**ZONING AND PLATTING COMMISSISON
SITE PLAN WAIVER REQUEST REVIEW SHEET**

CASE NUMBER: SP-2018-0155C **ZONING AND PLATTING COMMISSISON**
HEARING DATE: October 2nd, 2018

PROJECT NAME: Risher Martin Office

RisherMartin Office
3904 MEDICAL PARKWAY
AUSTIN, TEXAS 78756
SITE PLAN

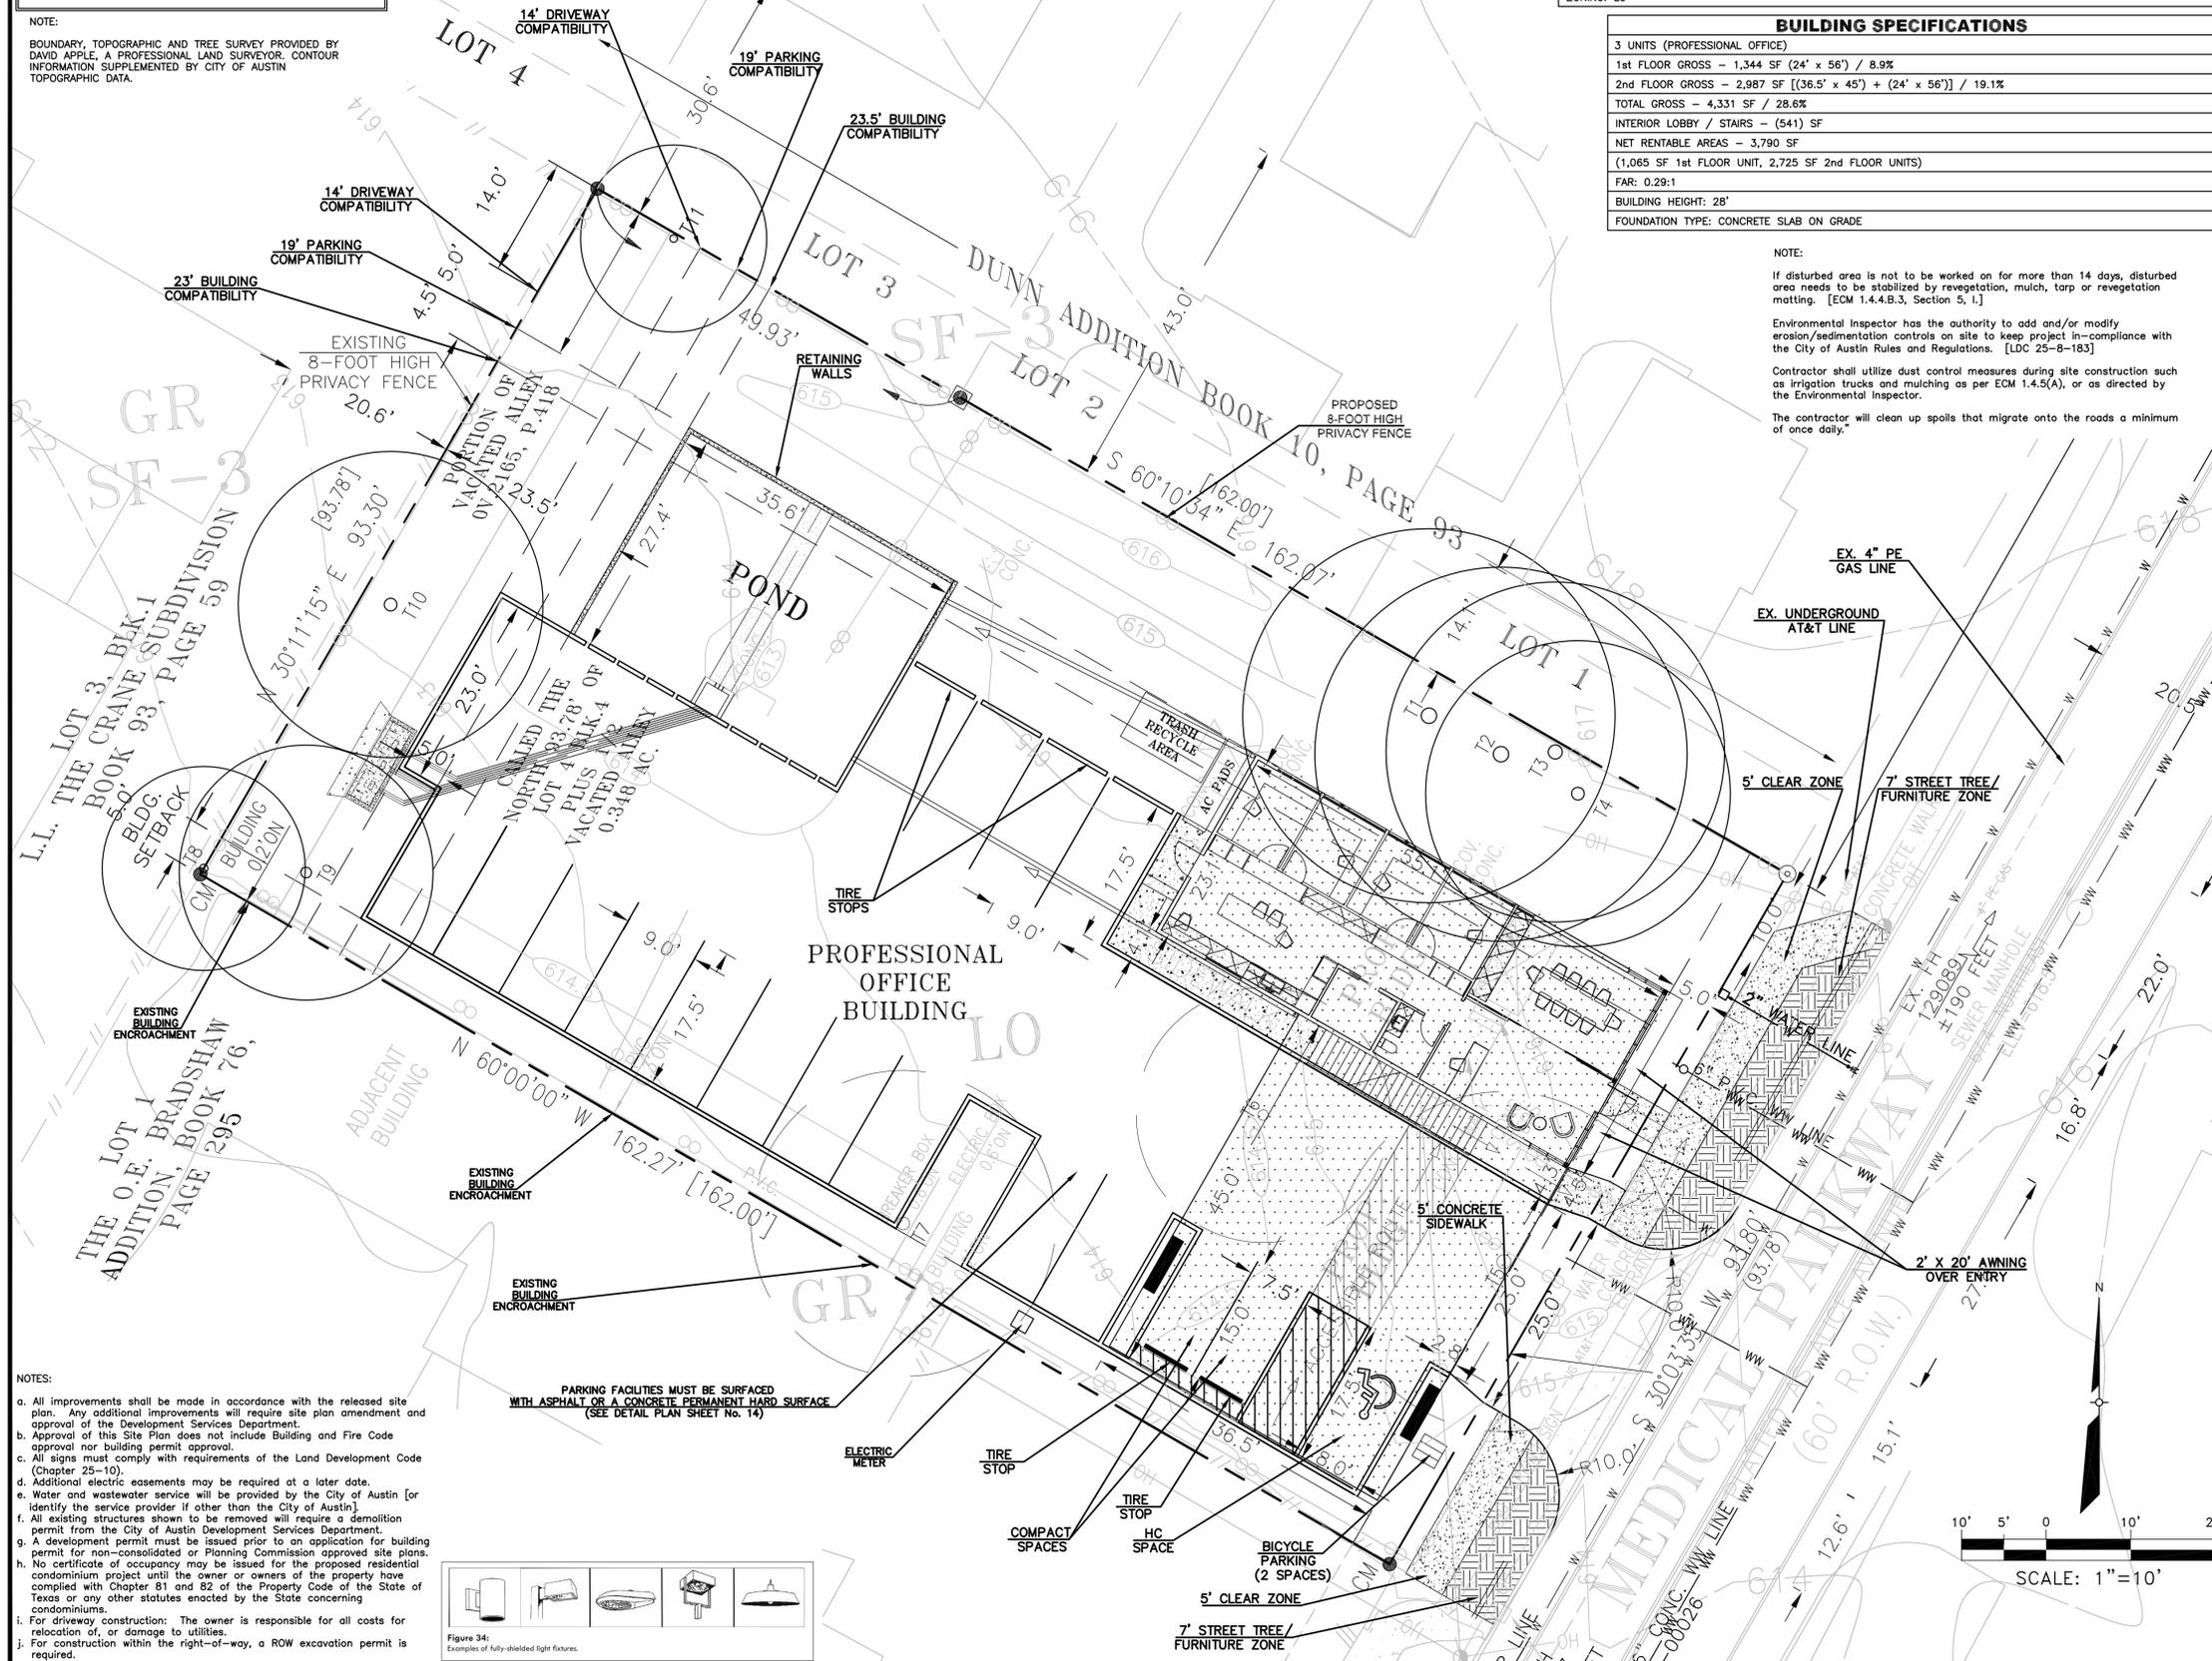
The applicant is requesting a Compatibility Waiver from § 25-2-1062(C), which requires construction and structures to be setback 23.5 feet from the triggering property lines.

The site is subject to Compatibility Standards due to the single-family structure, zoned SF-3 to the north and west. Per Section 25-2-1062(C) of the Land Development Code – A person may not construct a structure 23.5 feet or less from property in an urban family residence (SF-5) or more restrictive zoning district; or on which a use permitted in an SF-5 or more restrictive zoning district is located.

Staff recommends approval of the waiver requests. The size of the site causes constraints for development. The site plan complies with all other requirements of the Land Development Code.
